## **Happiness Bag – New Facilities**

September 16, 2024

### **Addendum #1**

SHEET NO.  
**A0.0**  
 JOB NO.  
 A24-006

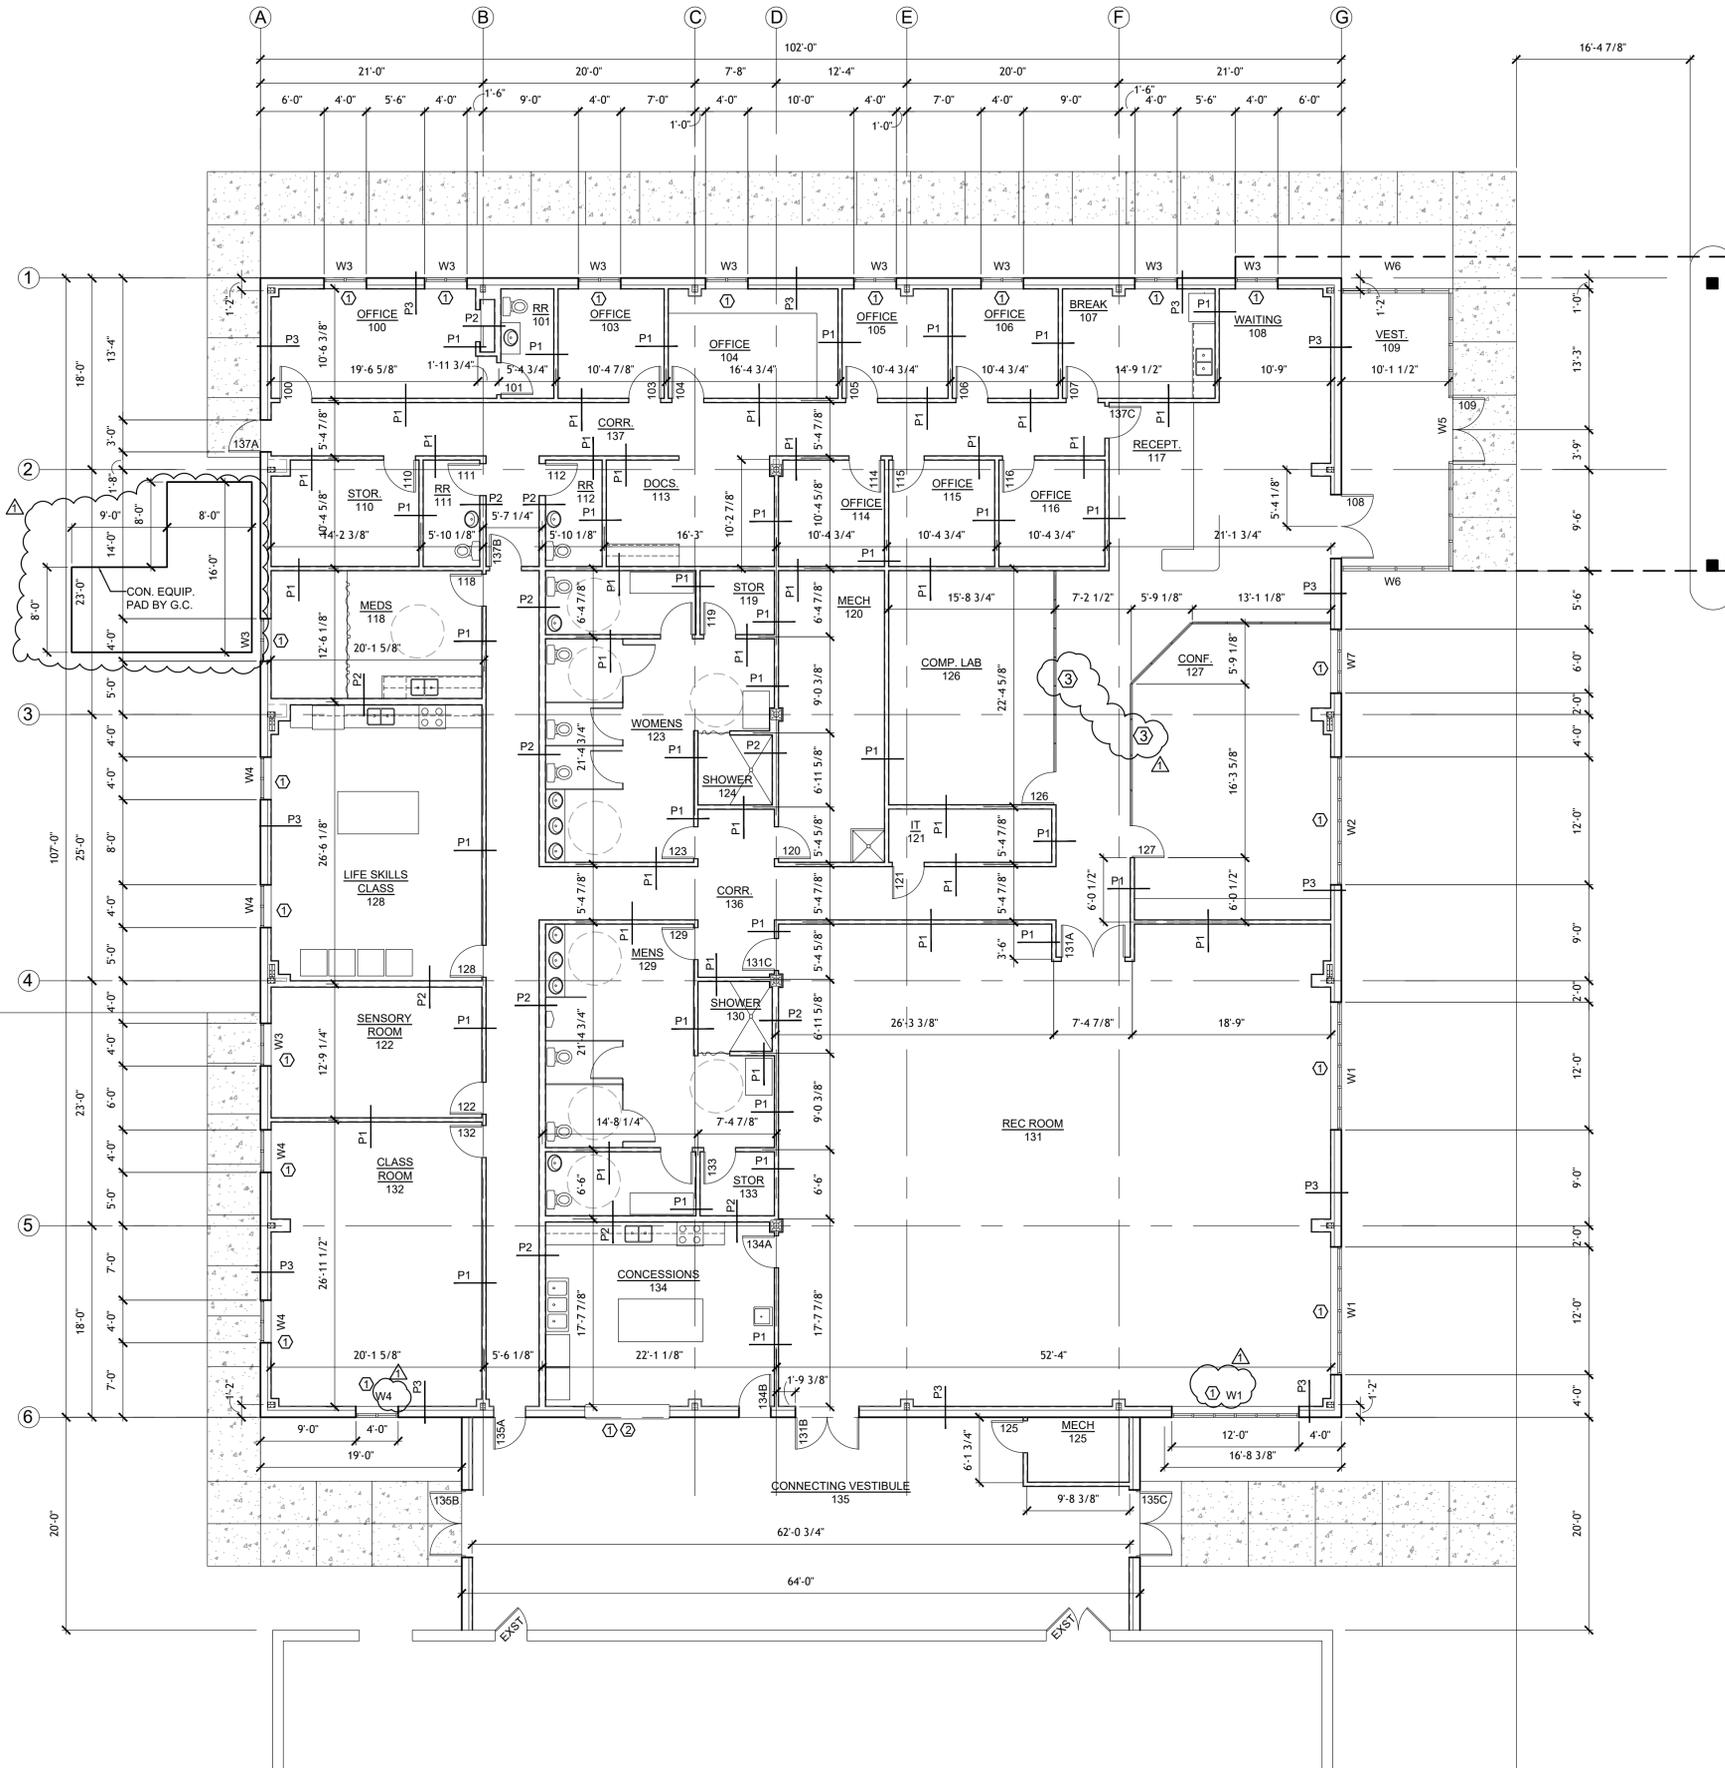
1. Replace sheet with attached sheet affixed with revision note 1 – Addendum 1 – 09.16.2024'
2. Drawing Index has been updated to include those sheets affected in the Addendum 1

1 REFLECTED CEILING PLAN  
 A2.2 SCALE: 3/16" = 1'-0"

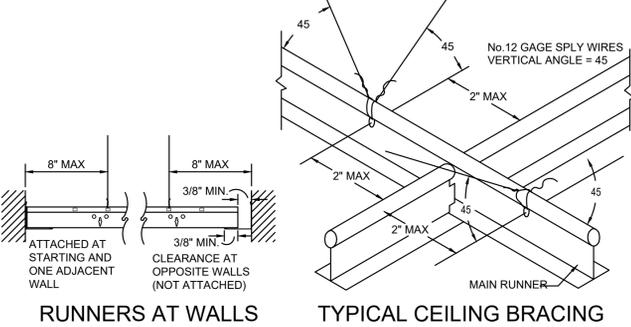
1. Replace sheet with attached sheet affixed with revision note 1 – Addendum 1 – 09.16.2024'
2. Revise Ceiling Notes, CI-2 to read, "CL-2: INSTALL WHERE NOTED, ARMSTRONG CEILING KITCHEN ZONE #672- 24" x 24" x 5/8" SQUARE LAY-IN 15/16". WITH PRELUDE ML EXPOSED TEE SUSPENSION SYSTEM

**1 SOUTH ELEVATION**  
 A3.1 SCALE: 3/32" = 1'-0"

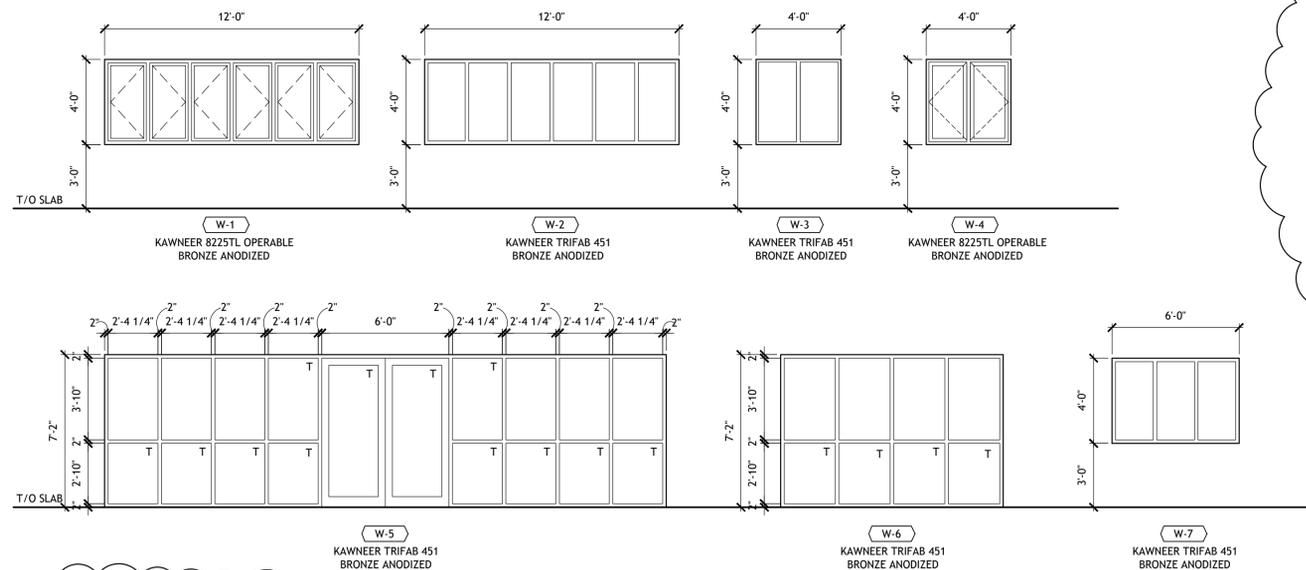
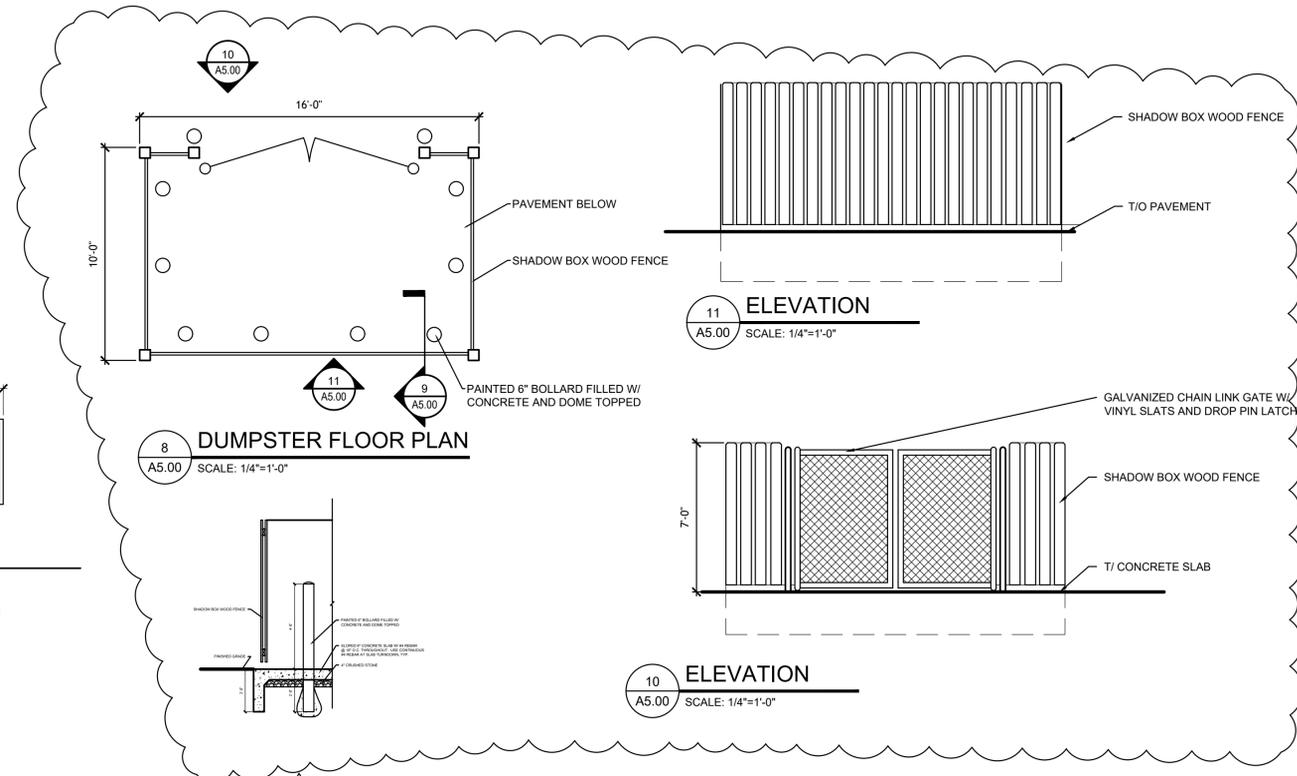
1. Added note 2. MEDIUM STILE DOOR NUMBERS 108, 109, 135B AND 135C".
2. Added dumpster enclosure information.
